PARK ROAD - ROAD SAFETY AUDIT (RSA)

Quaker Lane South to Prospect Avenue

RSA Date: October 24, 2023

Exhibit 3-5: Recommendations

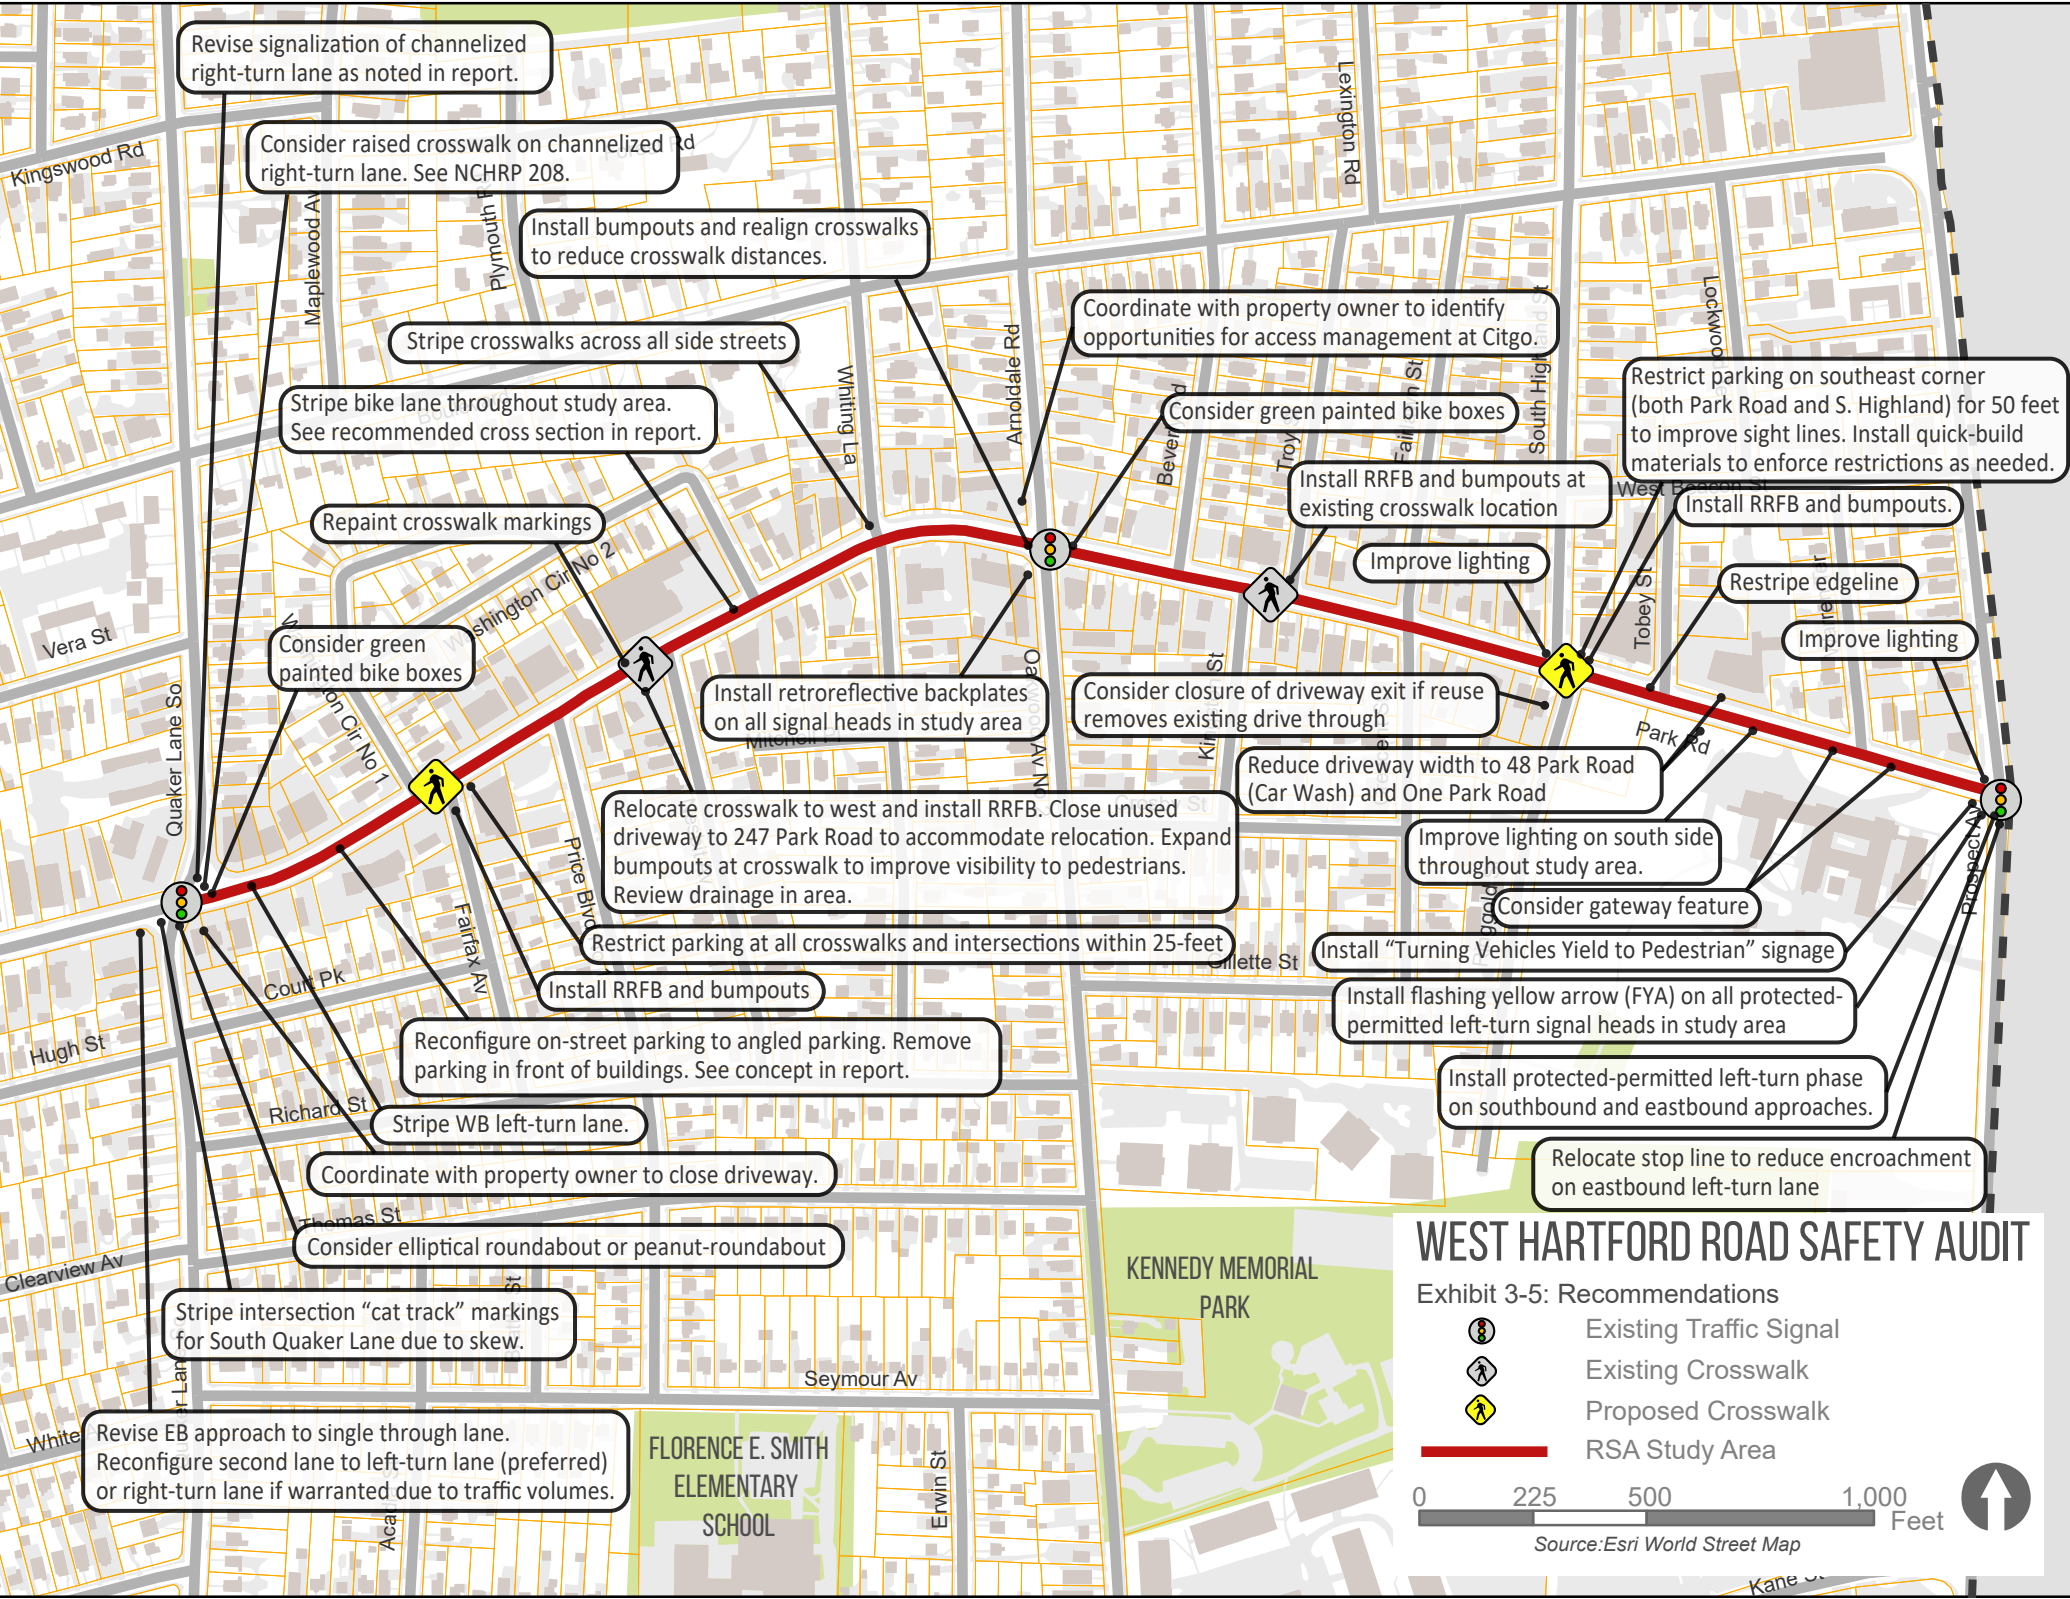
Revise signalization of channelized right-turn lane as noted in report.

Consider raised crosswalk on channelized right-turn lane. See NCHRP 208.

Install bumpouts and realign crosswalks to reduce crosswalk distances.

Stripe crosswalks across all side streets

Stripe bike lane throughout study area. See recommended cross section in report.

Install retroreflective backplates on all signal heads in study area

Install RRFB and bumpouts at existing crosswalk location

Restrict parking on southeast corner (both Park Road and S. Highland) for 50 feet to improve sight lines. Install quick-build materials to enforce restrictions as needed.

Install RRFB and bumpouts.

Relocate crosswalk to west and install RRFB. Close unused driveway to 247 Park Road to accommodate relocation. Expand bumpouts at crosswalk to improve visibility to pedestrians. Review drainage in area.

Restrict parking at all crosswalks and intersections within 25-feet

Reconfigure on-street parking to angled parking. Remove parking in front of buildings. See concept in report.

Install protected-permitted left-turn phase on southbound and eastbound approaches.

Relocate stop line to reduce encroachment on eastbound left-turn lane

Consider elliptical roundabout or peanut-roundabout

Stripe intersection "cat track" markings for South Quaker Lane due to skew.

Revise EB approach to single through lane. Reconfigure second lane to left-turn lane (preferred) or right-turn lane if warranted due to traffic volumes.

Exhibit 3-6: Cross section proposed for Park Road in the Study Area

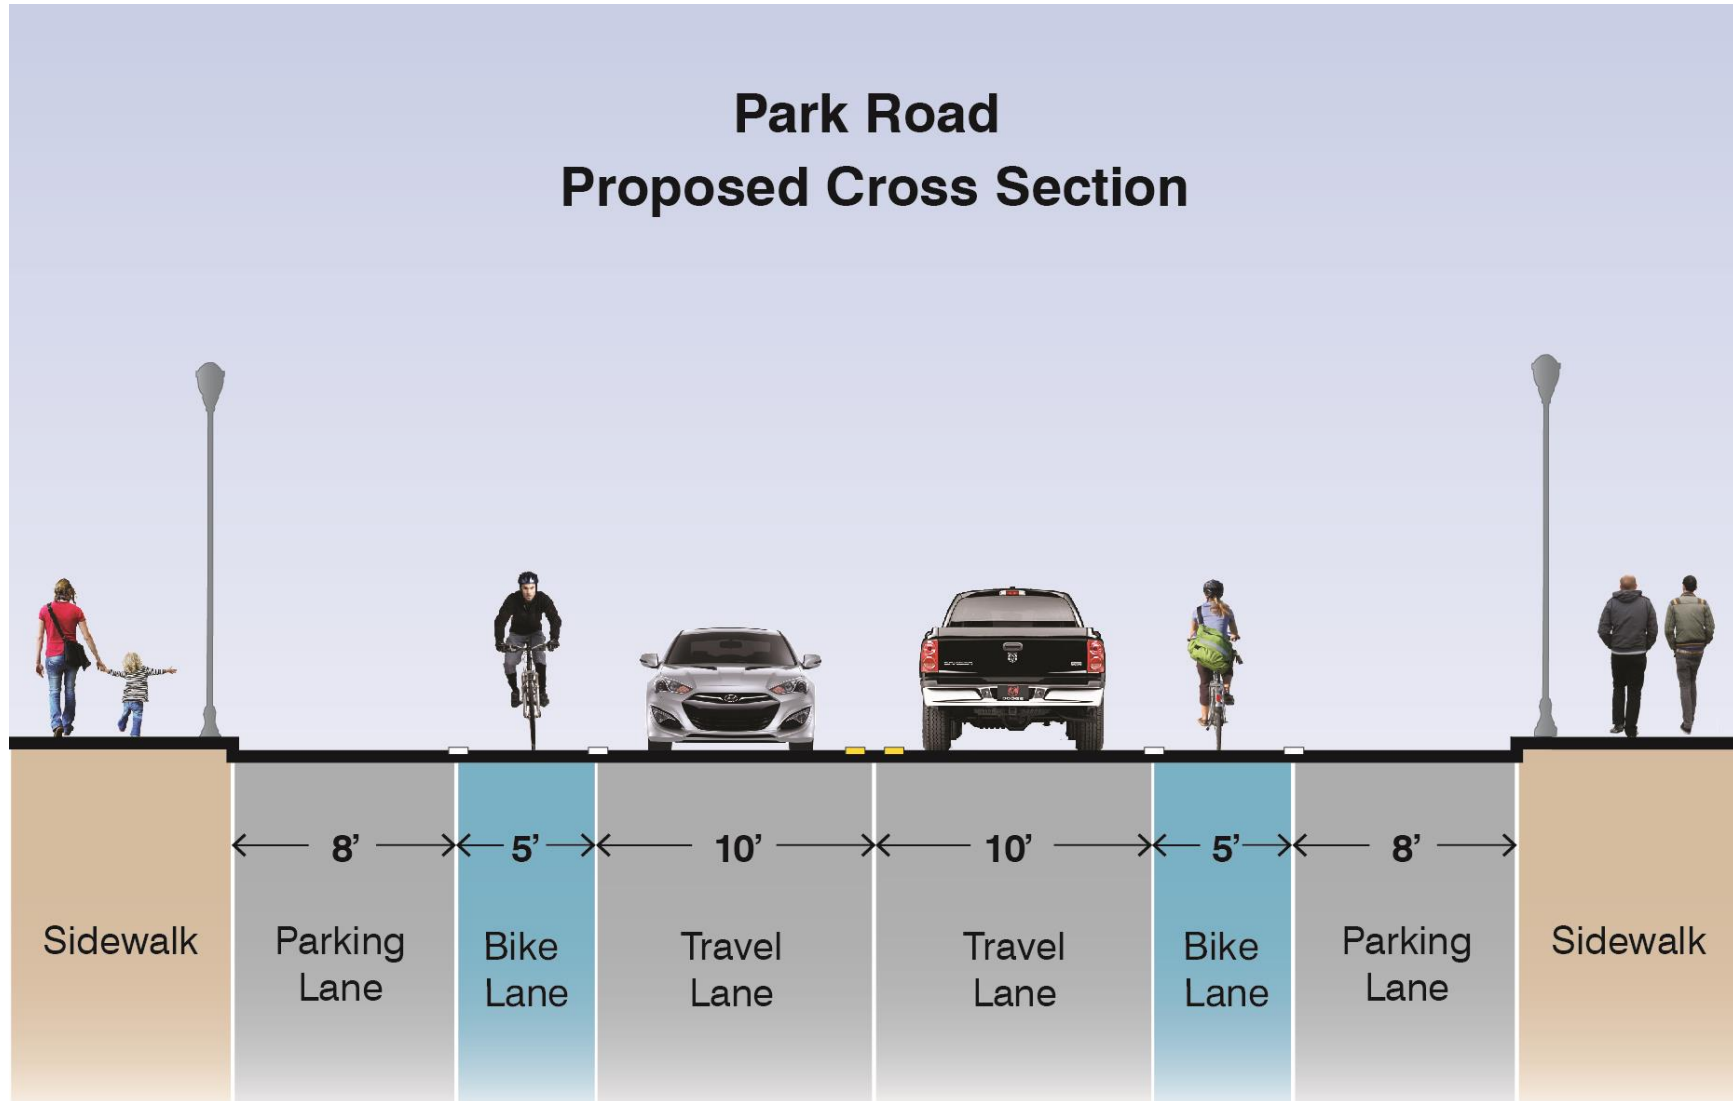
- The existing curb-to-curb width of Park Road in the study area is 46-feet. This represents **the minimum width recommended to support on-street bicycle lanes, travel lanes and parking on both sides of the street**. An 11-foot travel lane would be more typical on main roads with regular usage by large vehicles such as buses and trucks. However, the 10-foot travel lane that is recommended, in combination with a 5-foot-wide bike lane, provides a combined operational space of 15 feet for motor vehicles and bicyclists. Reduction of either the parking lane width (8 feet) or the bicycle lane width (5 feet) **is not** recommended as this would position a bicyclist closer to the door zone of parked vehicles. The proposed cross section for the study area is provided in Exhibit 3-6.

Exhibit 3-14: Concept for bumpouts and crosswalk for the intersection of Park Road, South Highland Street, and Ringgold Street

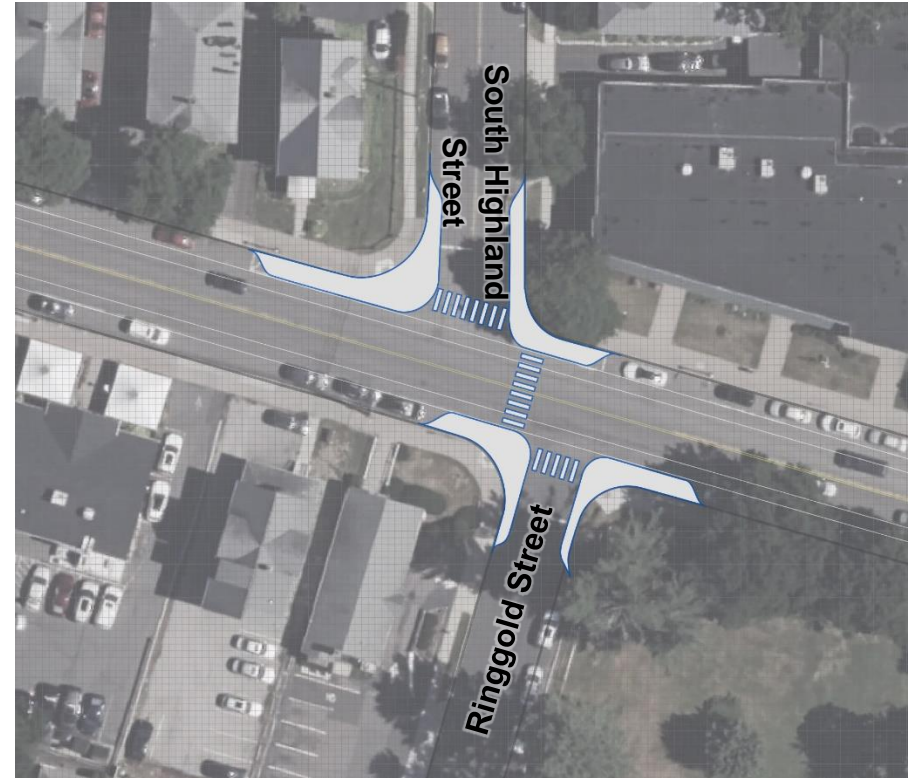
- A crosswalk was previously considered at South Highland Street by the Town. RSA participants noted this would be a good location for a crosswalk due to connectivity to the north. Ideally, this would be on the east side of South Highland and connect to the west side of Ringgold Street. Bumpouts would be required to make this configuration feasible.
- The crosswalk at Kingston Street was installed in 2018. Sightlines appear to be sufficient and this was found to be a good location. Lighting at this location was noted by RSA participants as poor. This location could be a good candidate for bumpouts and an RRFB upgrade with high-intensity crosswalk lighting. Refer to Exhibit 3-9.

- Restripe edge lines between South Highland Street and Prospect Avenue (currently in progress by town).
- Install crosswalk, bumpouts, and RRFB with high intensity crosswalk lighting at the intersections of South Highland Street and Kingston Street. Refer to Exhibit 3-15 and Exhibit 3-16 for examples of an RRFB. See Exhibit 3-14 and Exhibit 3-17 for a concept layouts.
- Restrict parking on southeast corner of Park Road and South Highland Street within **50-feet** of the intersection. While this restriction exceeds state law, the existing on-street parking was found to obstruct sightlines. This

recommendation eliminates one additional parking space from Park Road and South Highland Street. Consider quick-build materials to enforce parking restrictions as needed.

Exhibit 3-19: Concept for intersection of Park Road and Oakwood Avenue

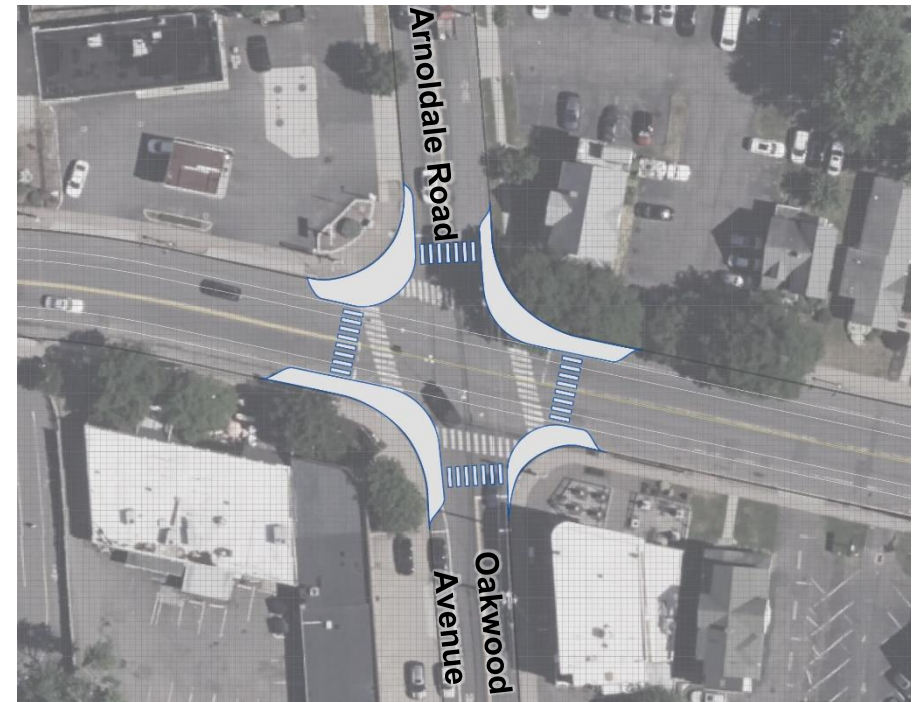
- Vehicles were noted as parking too close to the intersection, and obstructing sight lines to crosswalks.
- The southbound approach lane is approximately 18-foot wide. The width of this lane can encourage vehicles to double-up or pass, which was of concern to some RSA participants.
- The CITGO gas station has three driveways of significant width. This may be an area for access management.

- Restrict parking within 25-feet of crosswalk to meet state law requirements. Consider quick-build materials to enforce parking restrictions as needed.
- Consider green painted bike boxes.
- Install bumpouts and realign crosswalks to reduce crosswalk distances. See Exhibit 3-19 for a concept.

Exhibit 3-21: Crosswalk west of Nesbit Avenue at Playhouse on Park. View looking east. Note parked vehicle in front of unused driveway to 247 Park Road.

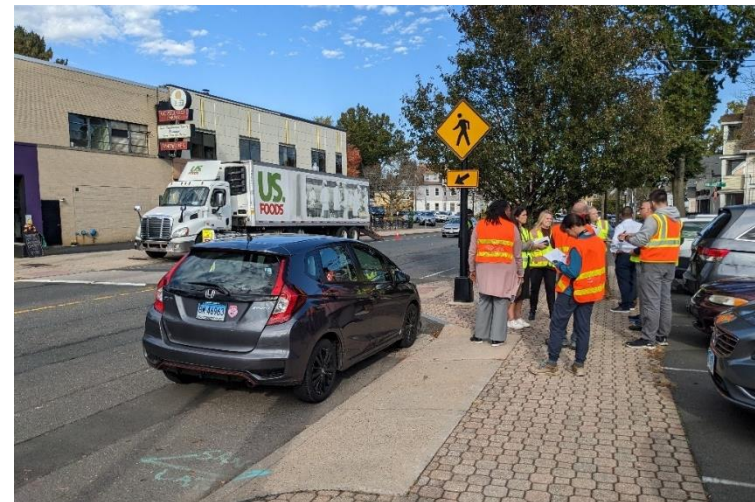
- The crosswalk just west of Nesbit Avenue (across from Playhouse on Park) is well utilized by patrons of area businesses. However, the visibility to the crosswalk was noted as a concern due to parking and truck-loading right up to the crosswalk. The crosswalk is constructed of decorative brick but lacks crosswalk markings on the east side due to recent repaving. The effect of the decorative material was discussed as these materials offer less contrast over standard crosswalk markings during nighttime conditions. There is an actuated LED sign for the crosswalk, however this predates more modern, and highly visible RRFB systems. See Exhibit 3-20 and Exhibit 3-21 which shows this crosswalk and the concerns noted.
- The driveway to 247 Park Road (European Motors) appears to be unused. This property is served by two driveways on Nesbit Avenue as well.

- Relocate crosswalk to west and install RRFB with high intensity crosswalk lighting. Close unused driveway to 247 Park Road to accommodate relocation. Expand bumpouts at crosswalk to improve visibility to pedestrians. Review drainage in area. Refer to Exhibit 3-22.
 - This concept eliminates 2 on-street parking spaces which are currently utilized but which would not be compliant with state law (if they were not grandfathered) which prohibits parking within 10-feet of a crosswalk when a curb extension is installed.

Exhibit 3-26: Concept for bumpouts and crosswalk for the intersection of Park Road, Washington Circle, and Fairfax Avenue.

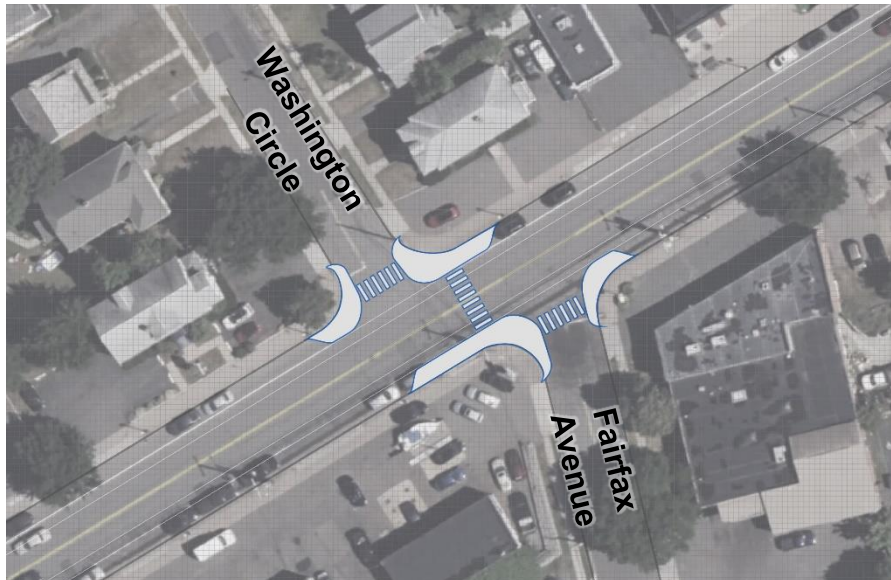
- Install crosswalk, bumpouts, and RRFB with high intensity crosswalk lighting at the intersection of Washington Circle and Fairfax Avenue. See Exhibit 3-25.
